## Chichester City Council

### PLANNING ADVISER'S REPORT FOR THE PLANNING AND CONSERVATION COMMITTEE MEETING ON 22 MAY 2025 AT 4PM

**CC/25/00559/FUL - Case Officer: Alicia Snook**

**The Atrium Southern Gate Chichester West Sussex**

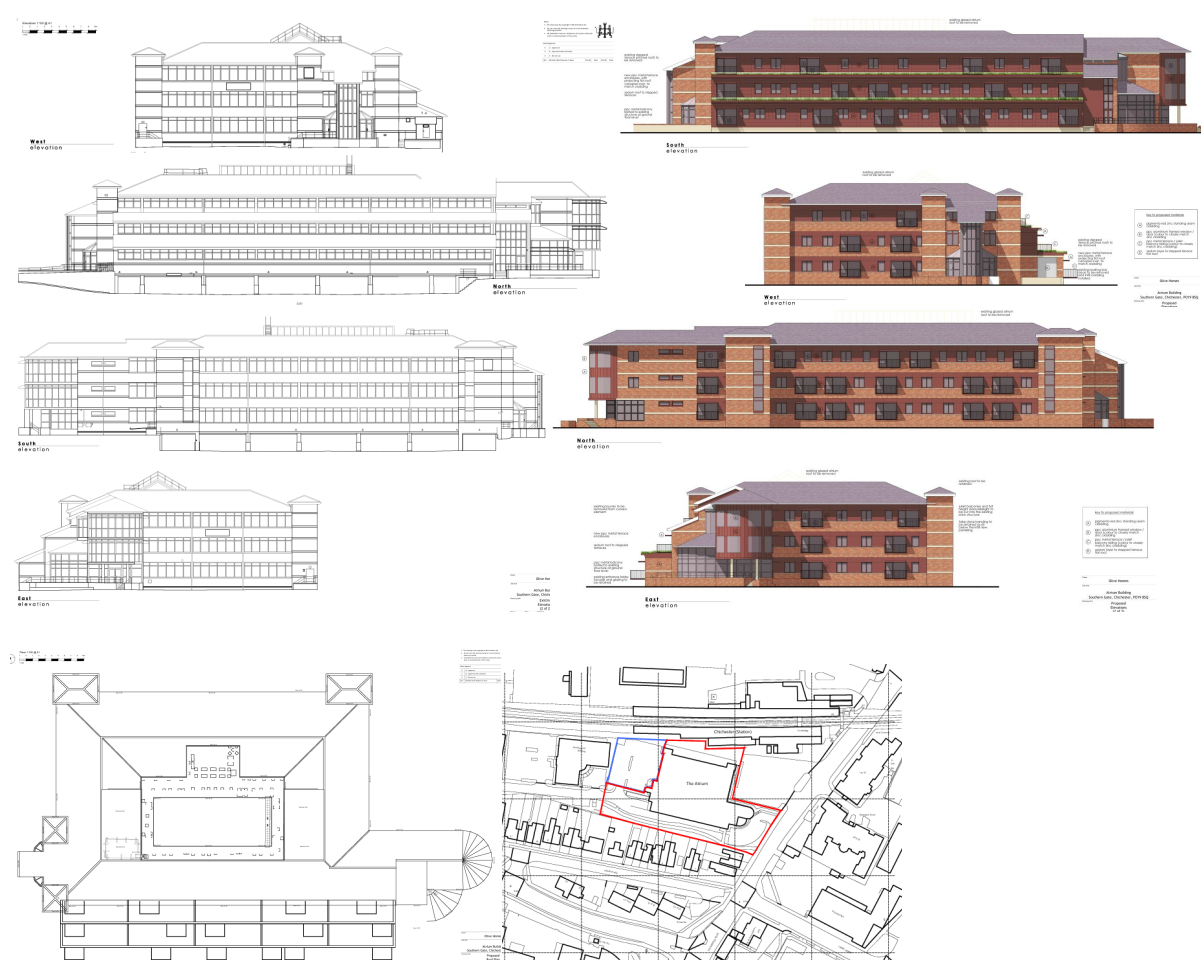
- **As the ground floor of the proposal site is set higher than that of the neighbouring properties to the south, all three floors of balconies would overlook the rear gardens and windows of properties along Canal Place. The increase in overlooking and perceived overlooking from the balconies and sedum roofs, which have the appearance of a rooftop garden, would be overbearing and would result in harm to residential amenity. The mature trees and hedging along the southern boundary of**

the site appear to be outside of the site, as the application form states that there are no trees or hedges within the site. As such, there can be no condition imposed for the retention and management of these trees to retain the screening effect they currently provide.

- It is noted that, on the First Floor Plan, the balconies do not align properly with the doors; the plan should be amended to show the correct position of the balconies and doors, which should correspond. The Juliet balcony railings on the north, east and south elevations are not shown on any of the Floor Plans.

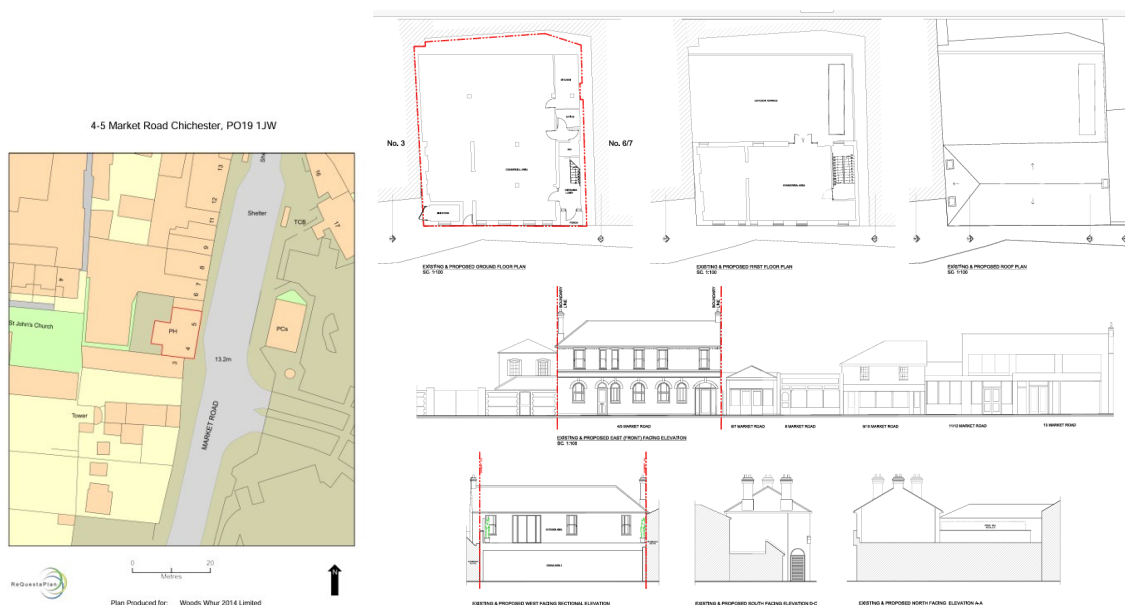
- **The development description specifies that the application is for a change of use of the ground floor only. This conflicts with the covering letter which states that the first floor would be used for offices; the proposed uses on both floors of the building should be specified and included within the application to enable the LPA to assess the acceptability and compatibility of the two proposed uses together. As the first floor is excluded from the development description, the effect of granting this permission on the first floor use is ambiguous and should be clarified. Concern is raised that the proposed development would prevent any viable use of the first floor, which could otherwise be valuable city centre floor space, which would have a negative impact on the vitality and viability of the city centre. Should the ground floor change of use be permitted, could the existing pub permission still apply to the first floor (resulting in conflicting uses and significant access issues through the gambling premises)? The application, including the description of development, should be amended to include and make clear the uses proposed for the whole of the building.**

- The Acoustic Assessment states that “There are no residences or other noise-sensitive premises in the vicinity of the front elevation, so noise breakout from this side of the building is not considered to be a concern”. AGC noise is recognised to be of a specific character and should therefore be lower in volume than other noises which more readily blend into the background noise. There should be no breakout noise to the front of the premises, as this would harm the character of the Conservation Area, which the LPA has a legal duty under s72 of the Planning (Conservation Areas and Listed Buildings) Act 1990 to preserve or enhance. Paragraphs 207-215 of the NPPF set out that no harm to designated heritage assets (which include Conservation Areas) must be allowed unless the public benefits of the proposal would outweigh that harm. There are limited public benefits to the proposal, which include partial use of the empty building, which would appear to permanently prevent the use of the remainder of the building. This would not outweigh the significant harm to the character of the Conservation Area of breakout noise of gambling machines, in this sensitive area, which is a main route into the city centre, with the site being between the city centre and the Market Car Park. It appears that a small internal lobby area could be created to both front doors onto Market Road to reduce noise break out. In addition, no assessment is made of the noise impact to the first floor of the building, which is excluded from the application, and the noise impact would have significant potential to affect any viable use of the first floor, (should independent access to it be secured in order to enable a separate use).

- The proposal mentions that the entrance would require external lighting for security, but no details of this are provided. External lighting may not be appropriate and may harm the character of the Conservation Area, which is a designated heritage asset. If the use requires external lighting, details of this must be submitted and approved at this stage, to ensure no harm would result.
